INDESIT company

Model type:
AVD88EX

Commercial code:
F029991

Fig . 001

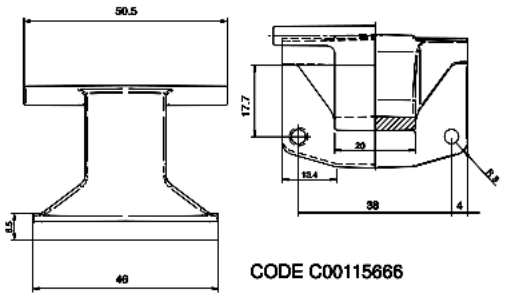
n1040349: Introduction of 150° Zamac hinge on Ariston 46 models.

From serial no. 50207.0001, all Ariston models produced in the Teverola factory (see table 001 attached) with industrial code (given on the rating plate) starting with 46, have been equipped with a Zamac hinge with 150° opening angle, code C00115666

(see Fig.001).
This modification has involved the introduction of the following items:

Code C00115670 - Complete door EVOII 150° white 27 with standard glass;
Code C00115674 - Complete door EVOII 150° white 27 with long glass;
Code C00115667 - EVOII body for 150° hinge white 27;

The premodified items are not interchangeable separately with the modified ones.

Code C00110133 - Complete door EVOII Standard 180° white 27 standard glass;
Code C00092157 - Complete door EVOII 180° white 27 long glass;
Code C00096193 - EVOII body for 150° hinge white 27;
